July 9, 2025  
File: 23403-A/B/C  
R2

**Re: Geotechnical Comments: Steep Slopes Construction Feasibility – Proposed Subdivision Development  
Pinnacle Ridge, Anmore, BC**

PINNACLE  
RIDGE  
HILLSIDE  
ANMORE, BC

PROPOSED PLAN  
OVERLAY  
SLOPE MAP

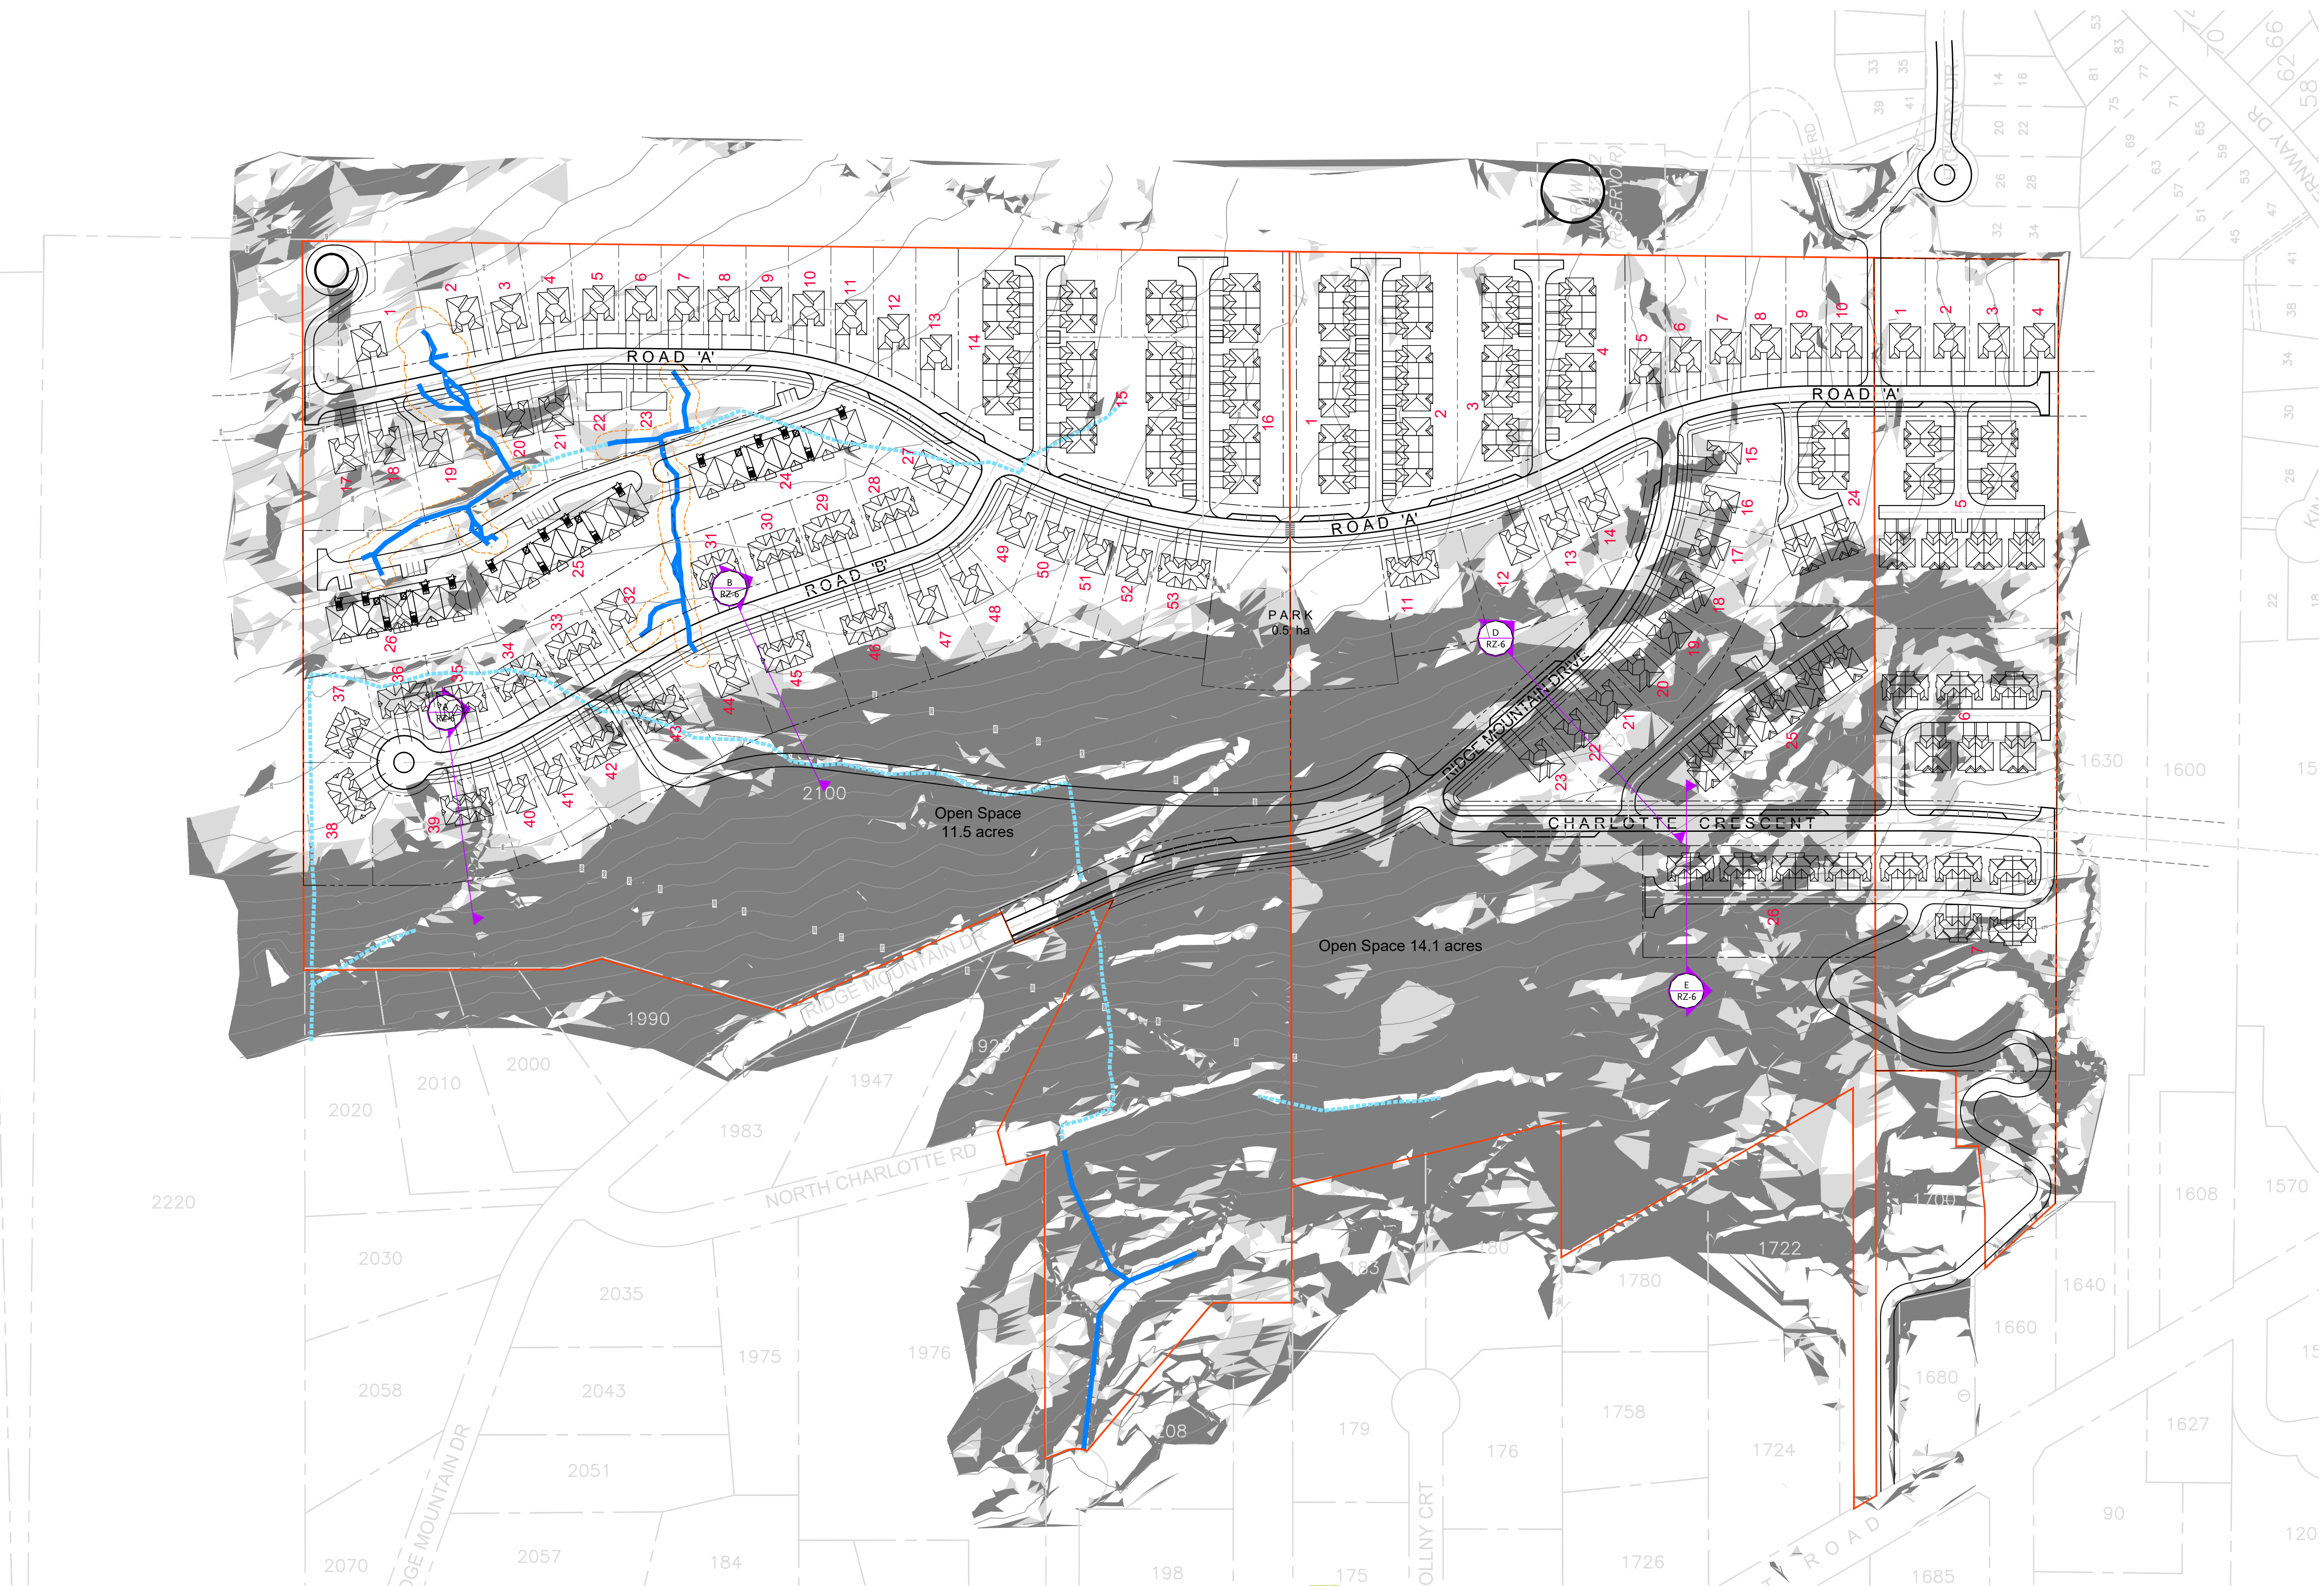
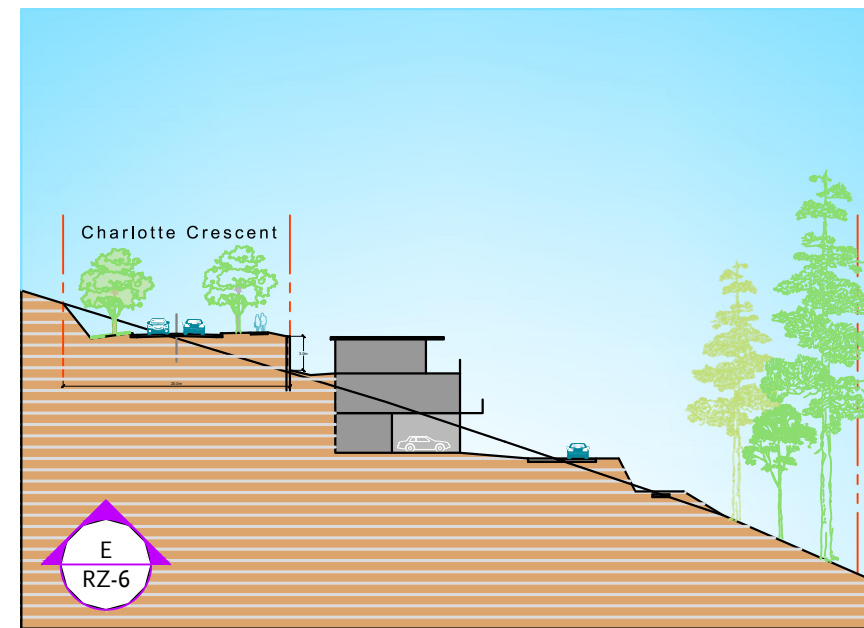
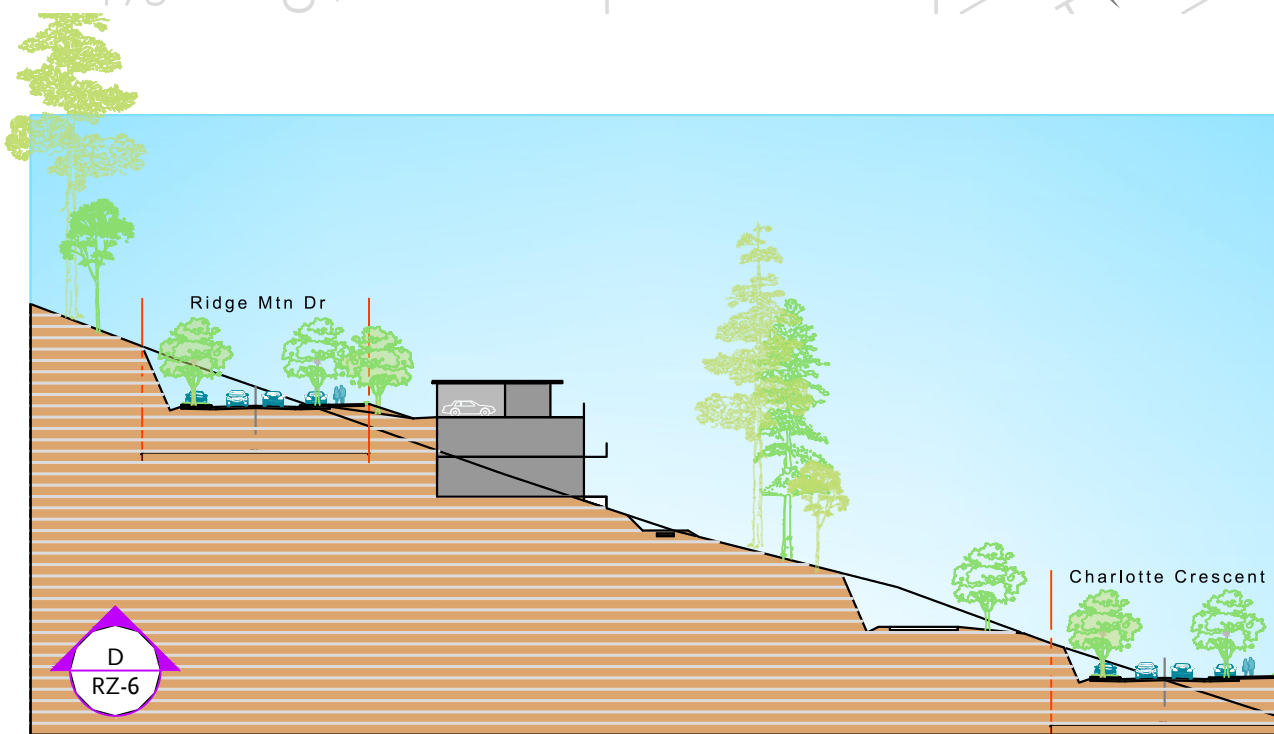
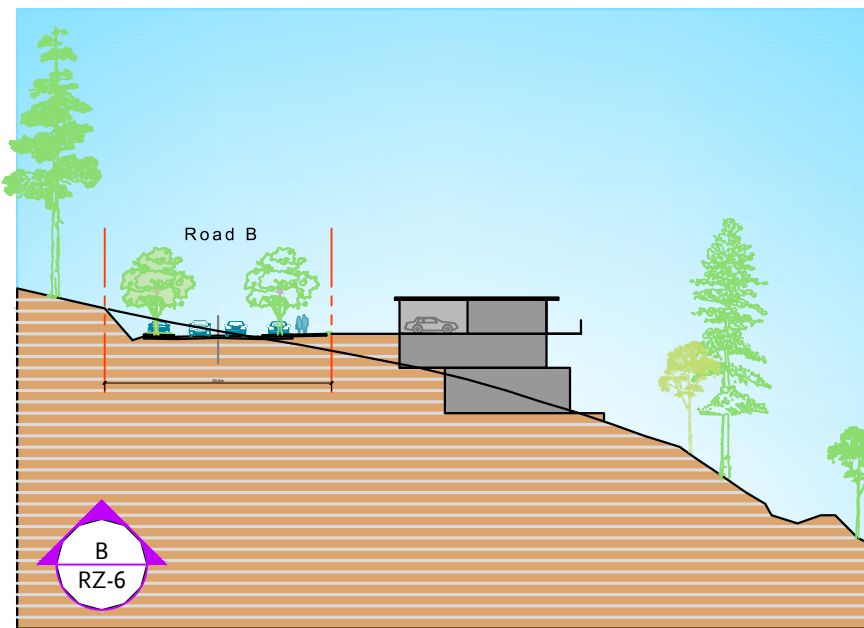
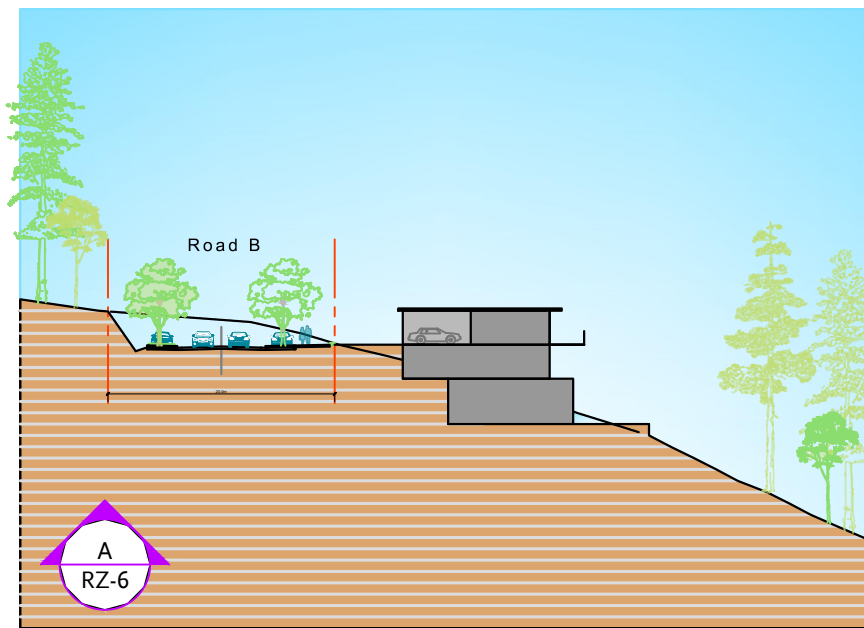
The site is within a bedrock controlled steep slope area with very dense glacial till overlying the bedrock. We understand the maximum slope around the aforementioned development lots is up to around 40% slope (22 degrees incline), which is considered moderate from a geotechnical perspective and is be considered to be relatively stable against slope instability considering the very dense glacially derived soils near the surface grades throughout the site and pre-tertiary bedrock below.

Structures (residential homes and retaining wall structures, such as those along roadways and yards) which are founded on steep slope areas would have the foundations constructed directly above the very dense glacial till layer. Once detailed design and grading drawings are completed, slope stability assessments in accordance with EGBC can be completed for relevant lots with grades exceeding 30%.

From a geotechnical perspective, permitted the residential structures and roadways are constructed in accordance to the recommendations in our geotechnical reports and future recommendations throughout the permitting process after detailed design drawings are available and those during construction, it is our opinion the construction the subdivision and residential homes is feasible from a geotechnical perspective for areas with slopes up to around 40%. GeoPacific has also been involved in residential developments within the Pinnacle Ridge Estate Phase 1 development which were constructed on slopes greater than 30%, including 1975 North Charlotte Road where geotechnical aspects (below grade foundation walls and retaining walls) have been constructed successfully. We note other residential developments in the Pinnacle Ridge Estate Phase 1 are also constructed on slopes over 30%.
